19 November 2012, Revised 14 December 2012

Re: Design Narrative for Bayshore District Operations Building

figure a.

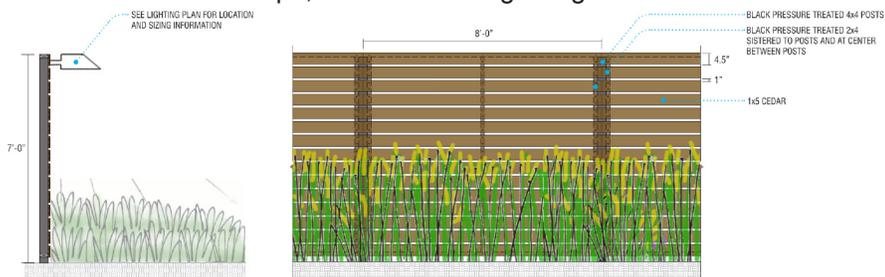
1. Reconsider the proposed design of the perimeter fence. (Planning Commission, Cannon Design Group)
2. Provide a turn around in the visitor parking lot. (Cannon Design Group)
3. Consider repositioning the elevator to open up views into the courtyard. (Cannon Design Group)
4. Consider further the location of panel joints in the pre-cast brick veneer panels. (Cannon Design Group)
5. Make adjustments to the “heaviness” of cantilevered elements at the 2nd story. (Cannon Design Group)
6. Address concerns about the “hardness” of the materials proposed. (Planning Commission)

Referring to the diagrams below (figure a, figure b) you will see that we have eliminated the interior chain link fence and have replaced it with a wood fence composed of horizontal wood slats affixed to wood posts. This design solution addresses the Planning Commission’s concern about the quality and nature of the fence being sympathetic with the residential surroundings. Furthermore, the fence slats are spaced to limit visibility of the service yard, but also to facilitate the growth of vines over time. As originally proposed the location of the new wood fence is setback from the sidewalk a significant distance (figure c.) and will work with the low cable fence at the site’s perimeter to encourage pedestrian traffic to stay within the public realm and provide an acceptable level of security to the service yard itself. Additionally, property owners of the adjacent single family homes were engaged to discuss landscaping and fence treatment along the shared property line. These meetings occurred on 9/27/12 and 10/2/12 respectively. The property owners expressed support for the project and had no stated concerns with the landscape, fence or building designs.

figure d.

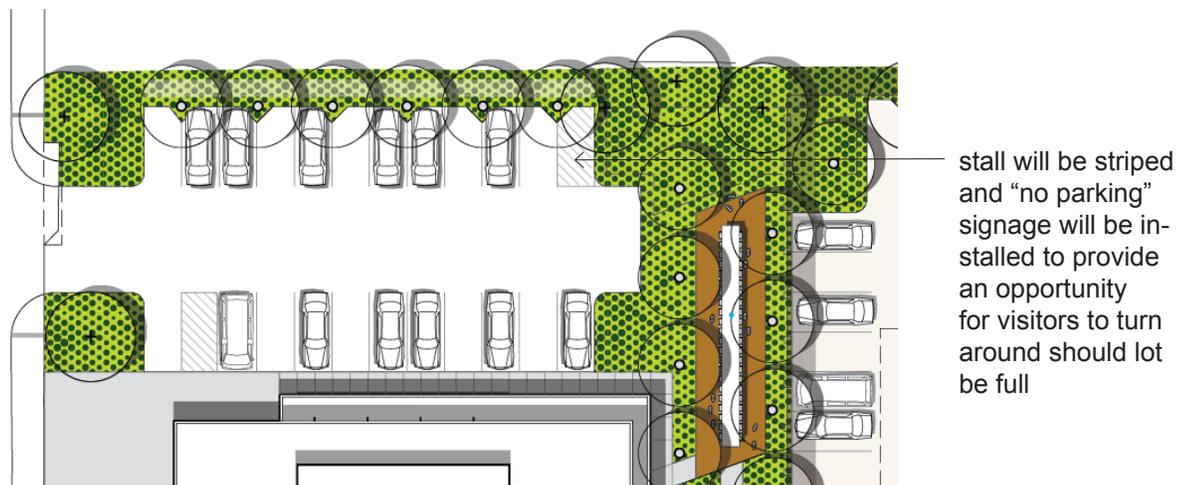
Pursuant to Cannon Design Groups comment regarding the dead end condition in the visitor parking area, we will provide for a turn around as shown in figure d. below.
